# Taylor Wimpey and Homes England

Pickering's Farm Planning Appeal

VN211918 Transport and Mobility Rebuttal of Mr N. Stevens and Dr. D Price Evidence

Technical Note 14: Response to LCC Modelling Proof of Evidence

Figure 12 Journey Time Impacts (Background Demands Uplift Sensitivity Test) – A582 Corridor - Northbound

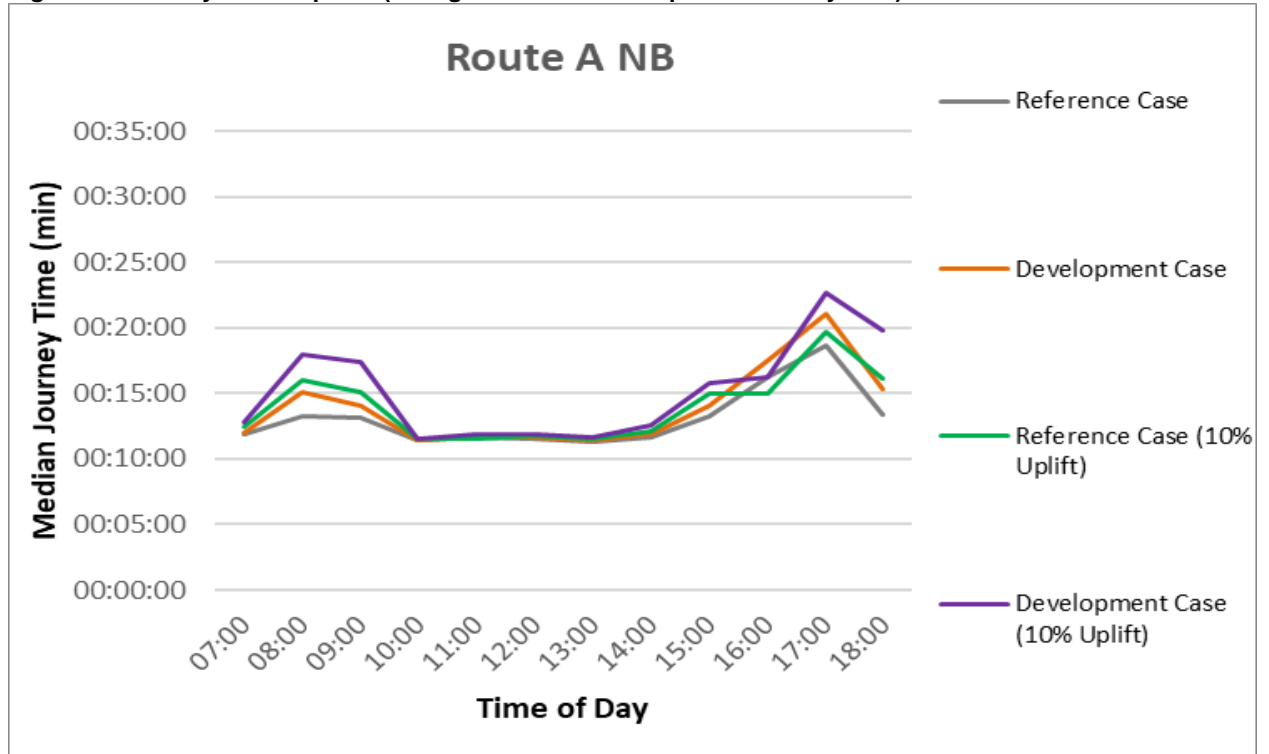
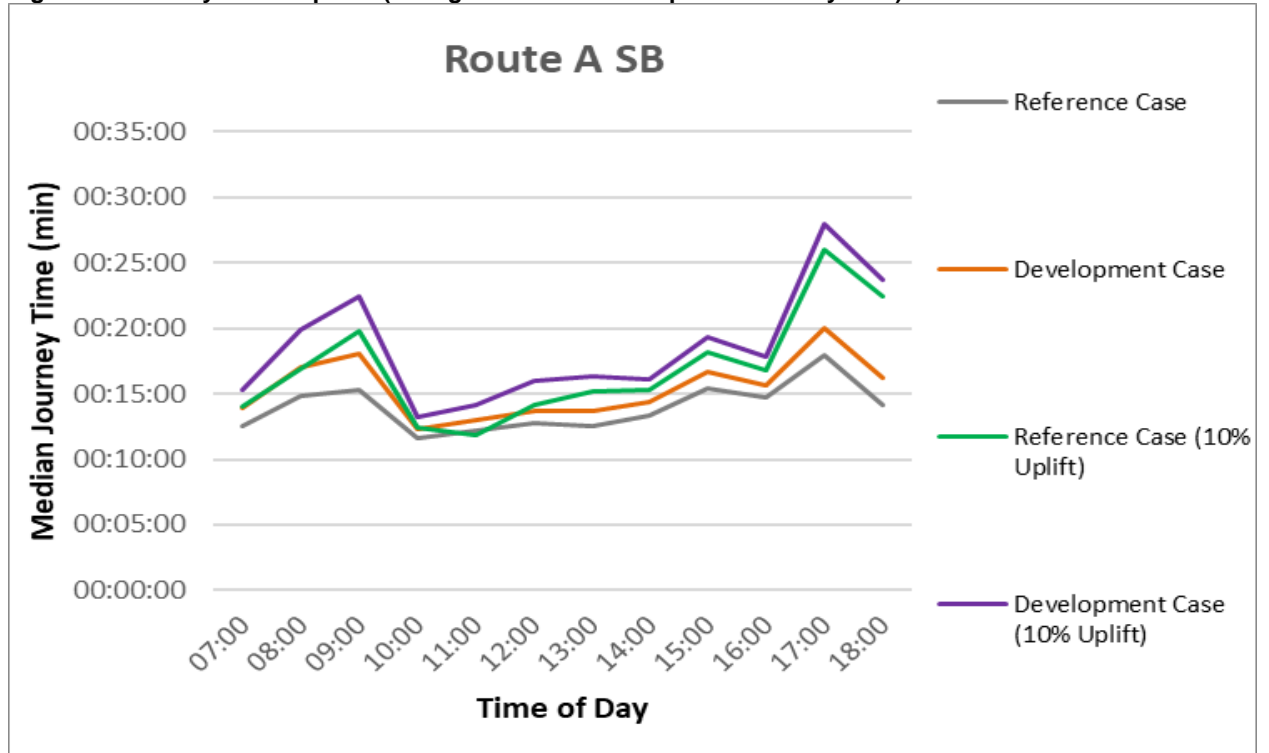
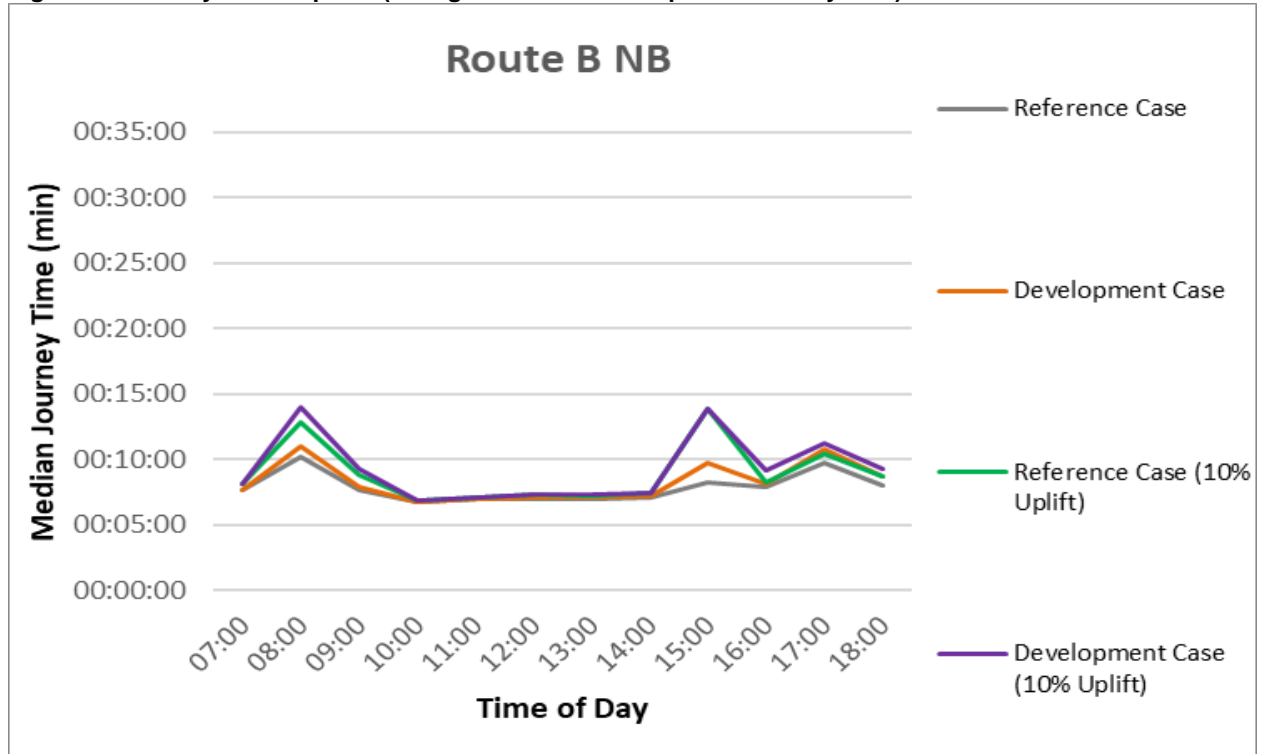
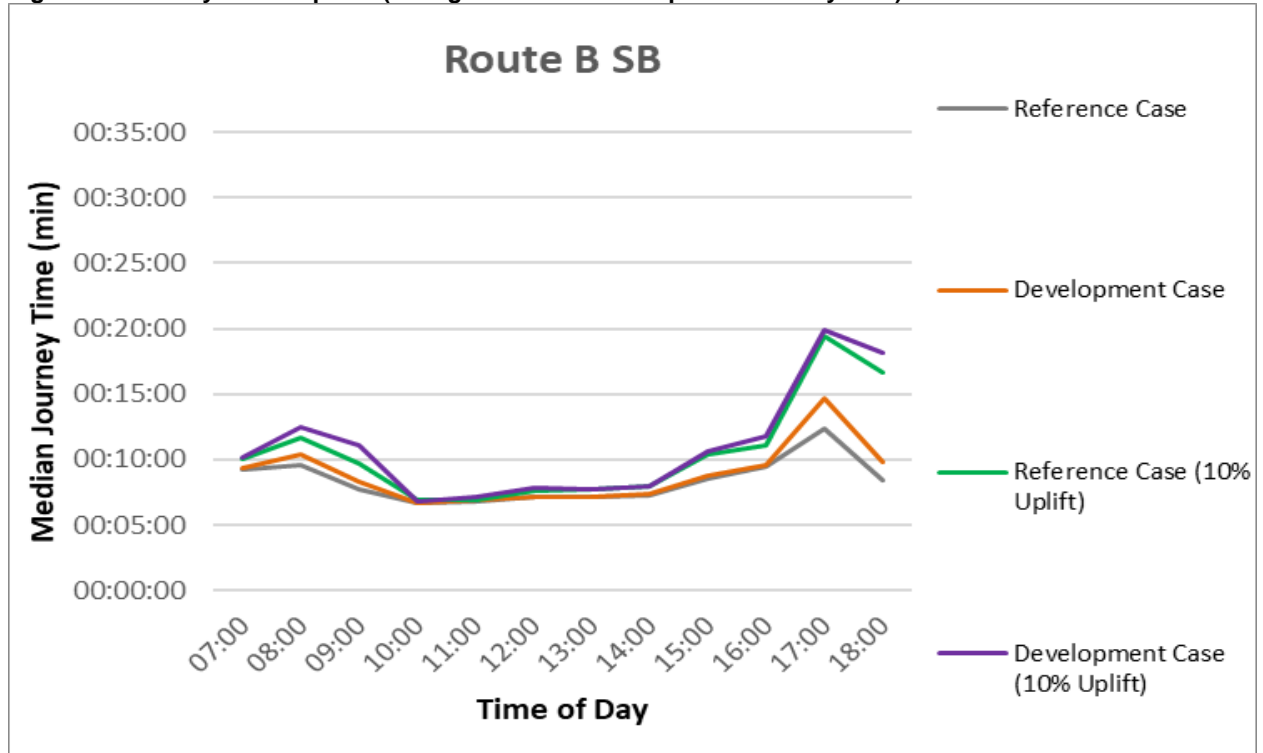
146. The journey time results presented for the key corridors in the previous **Figure 12 to Figure 15** provides the outputs from the uplifted background demands test undertaken by Vectos. This journey time analysis demonstrates that, regardless of the volume of traffic considered within the modelling, the magnitude of change between the Reference Case and Development Case scenario remains broadly consistent.

147. The journey times reported in the uplifted demands scenarios are higher than the originally reported outputs, however, this is the case for both the Reference Case and Development Case scenarios. Critically, the 'step change' in modelling outcomes is broadly consistent. The development, at times, induces increases in journey times which are similar in magnitude, when compared to the reference case journey times, with or without the 10% uplift.

**Figure 2: Journey Time Routes – Route 4**

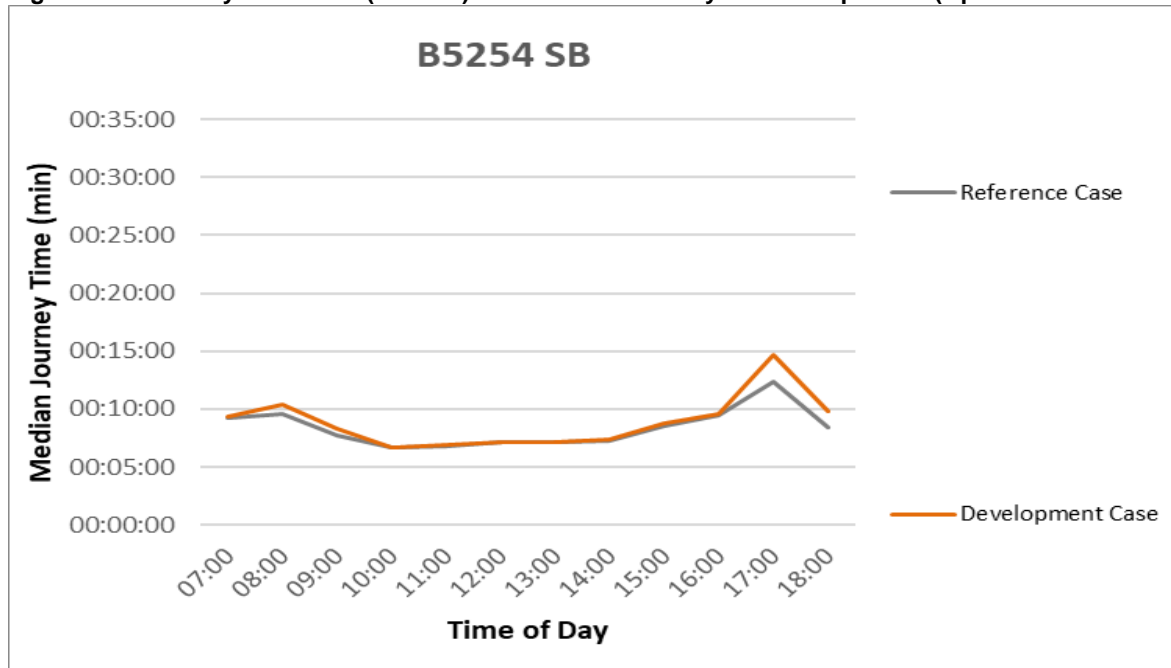
21. In response to the above point, it is again important to point out that this increase in journey times is reported for the PM peak hour only, with impacts across the rest of the day being negligible. It is also important to note that the signal timings at the A582/Watkin Lane/Stanifield Lane roundabout have been adjusted within the Development Case scenario in an attempt to maximise throughput on the A582 arms, which in turn worsens the performance of the B5254 SB approach referred to in this comment.

22. Following the update to the models recently undertaken, in which signal timings have been optimised in line with the LinSig models, this journey time impact is reduced (difference between Reference and Development is now less than 2 minutes), as highlighted within the following **Figure 2**.

23. This would indicate that the increase in delay originally reported within the TA can be reduced through improvements to the modelled signal timings assigned to the A582/Watkin Lane/Stanifield Lane roundabout.

Figure 4: Journey Time Routes – Route 6

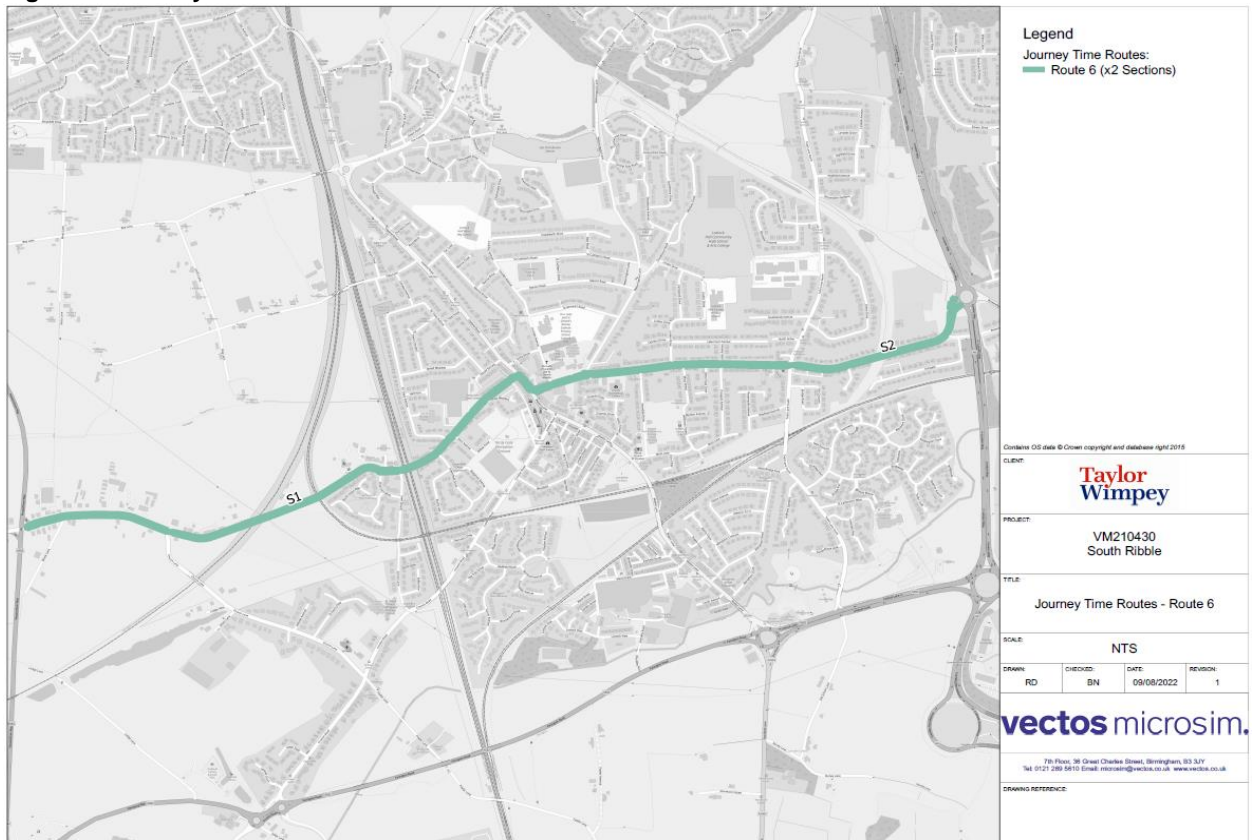
26. Following a review of the isolated junction models, optimised timings have been included at this location which in turns has reduced journey times on this approach, with the resultant impacts demonstrated within **Figure 5**.

Figure 1 AM Peak Development Impact on SRN

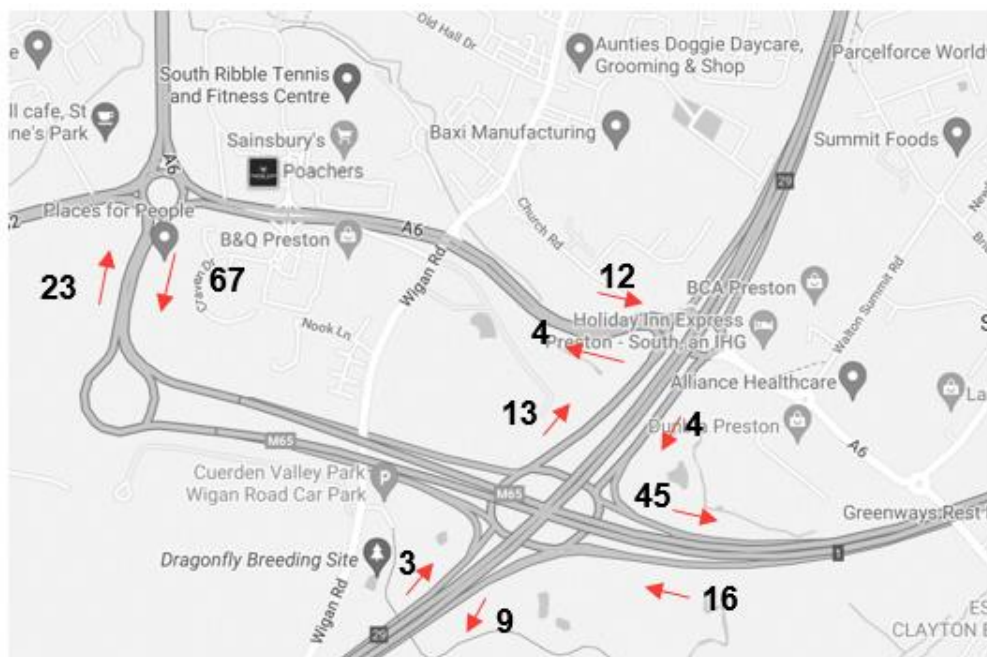
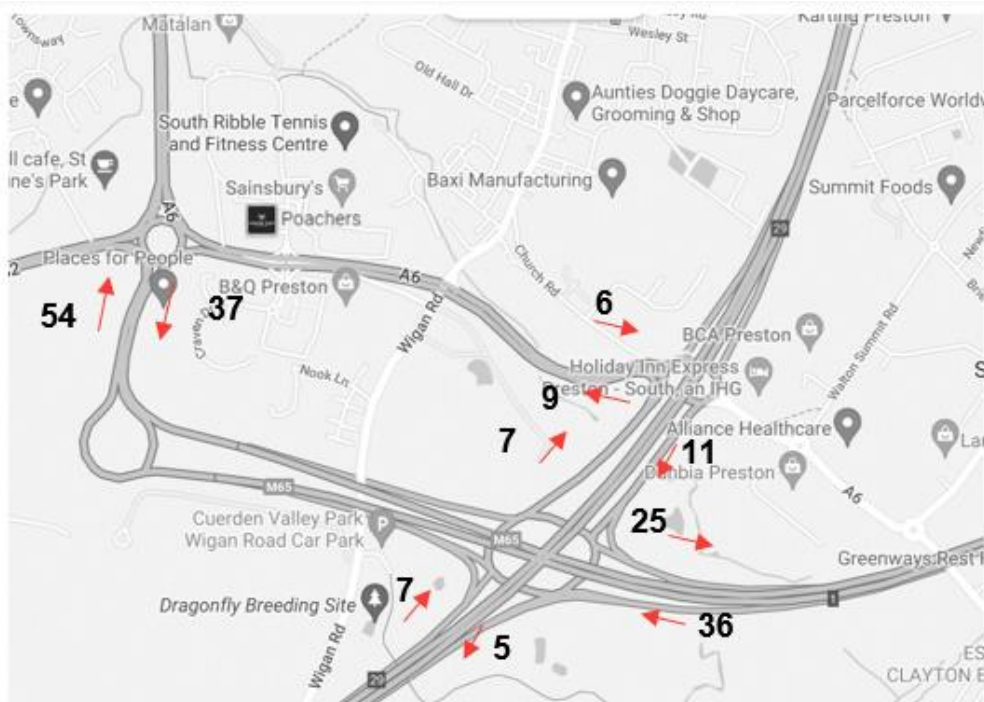
The forecast number of additional trips at the M6/M65 interchange as a result of the proposed development are shown in Figure 1 and Figure 2.

In the morning peak period 61 passenger car units (PCU) are forecast to pass through the M6/M65 junction (45 eastbound and 16 westbound) to/from Blackburn. 29 PCU are forecast to use the interchange entering or leaving the M6, this equates to only 1 PCU every 2 minutes. 16 PCU travel through the M6/A6 junction equating to only 1 PCU every 4 minutes.

Similarly in the evening peak period, an additional 61 PCU are forecast to travel through the M6/M65 Junction (25 eastbound and 66 westbound). An additional 1 PCU every 2 minutes are forecast to travel to/from the M6, 30 PCU in total. Finally, 15 PCU are forecast to use the M6/A6 junction, 1 PCU every 4 minutes.
